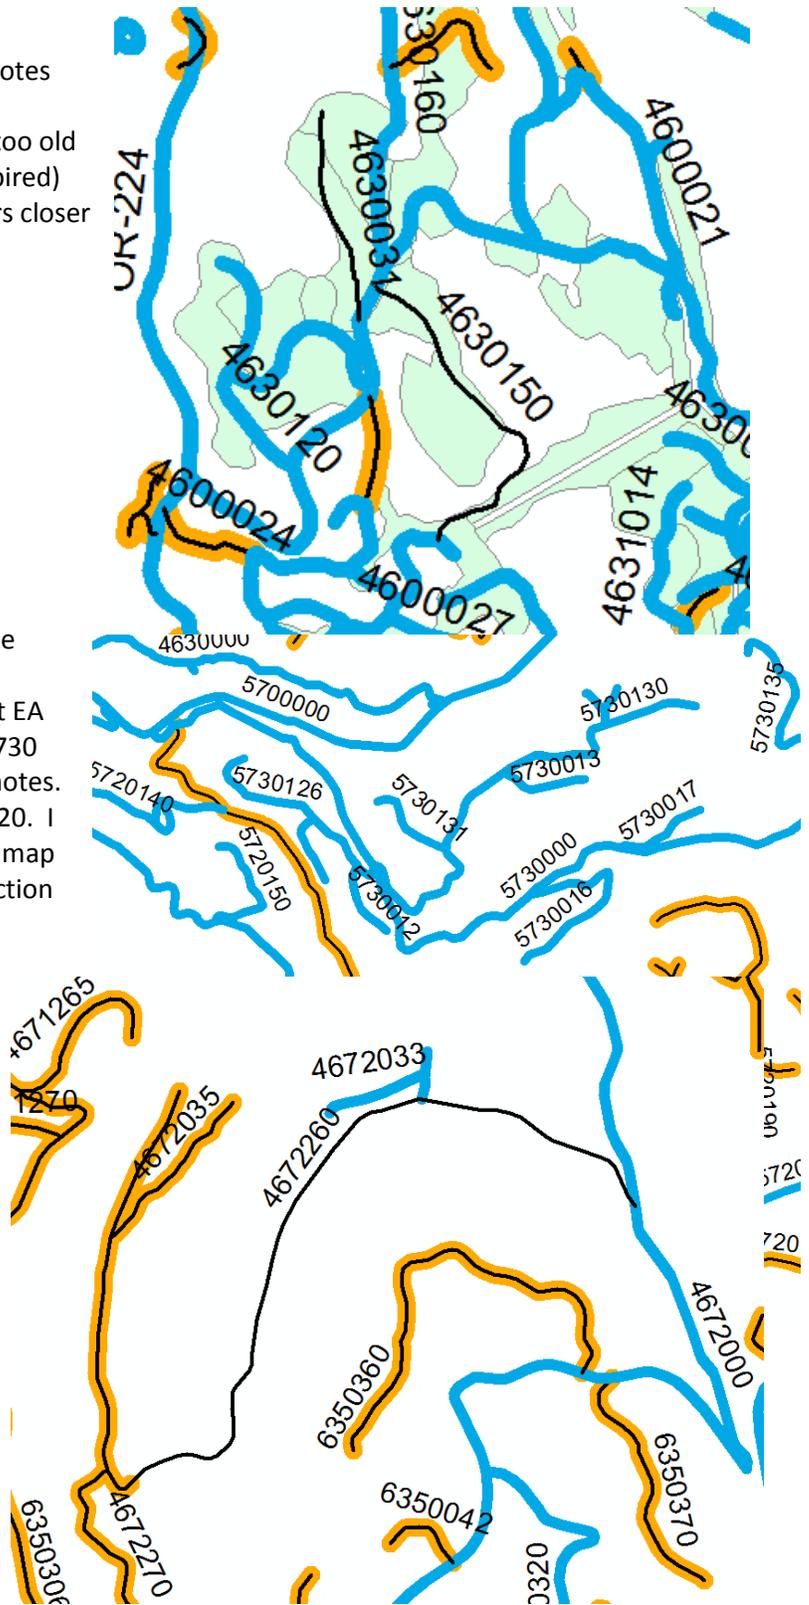
decommissioned in the yellow section which if it were true would leave 136 inaccessible. 136 is needed and needs to show that it connects to 4611. It is open and drivable. 140 has been decommissioned but not as shown on this map. it is decommissioned east of the 136 junction.

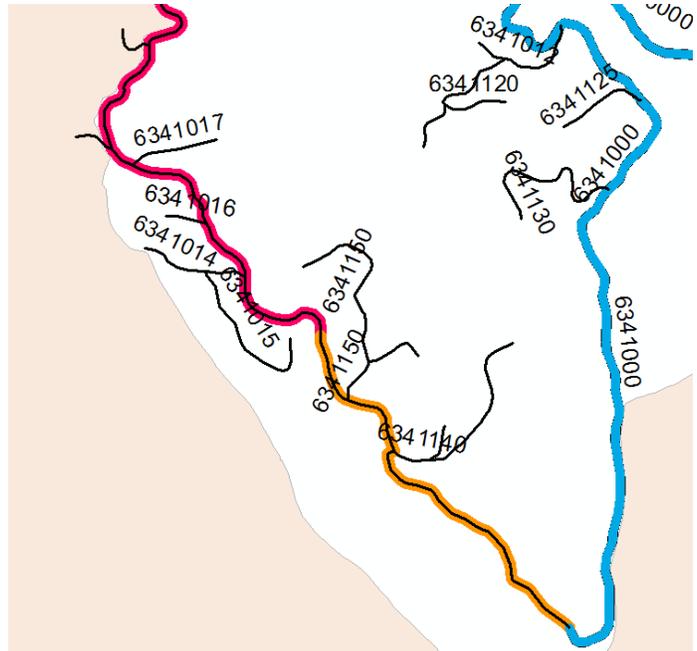
Road 6341 is coded incorrectly in the yellow section. The notes show that past mp 3.48 the road is decommission with delay from the 2011 increment 2 EA. That is appropriate for the red section but not the yellow bit. The milepost break is wrong – whoever entered this looked at the wrong alternative. The selected alternative keeps the yellow bit open.
